URGENT MEDICAL DEVICE CORRECTION

Product Correction #: RA 2014-169

Description: Triathlon Distal Capture Assembly

Product Correction Bulletin Triathlon Distal Capture Assembly

Figure 1

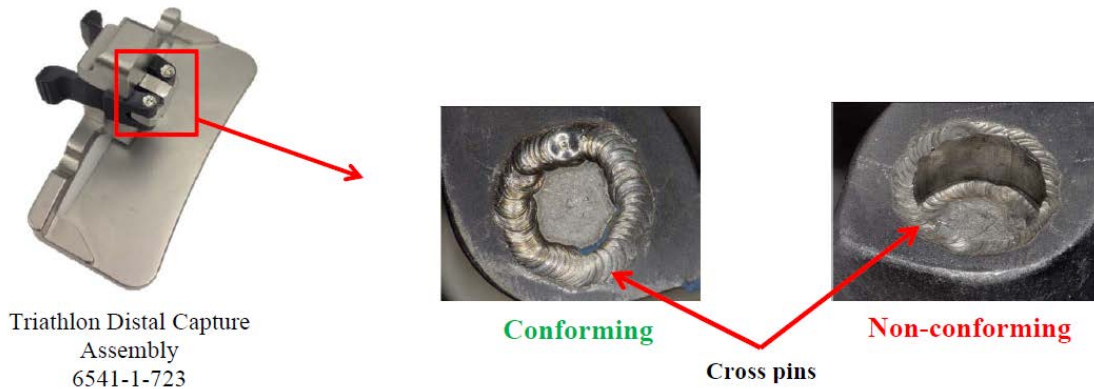
Stryker Orthopaedics has received complaints regarding the disassociation of the cross pin from the action triggers of the Triathlon Distal Capture Assembly, part number 6541-1-723 which could lead to a loose or disassociated action trigger mechanism and/or loose or disassociated cross pin.

Apply pressure and squeeze the Action Triggers on the Triathlon Distal Capture Assembly and visually inspect the cross pins to identify that the weld is properly maintaining the cross pin in the appropriate position*.
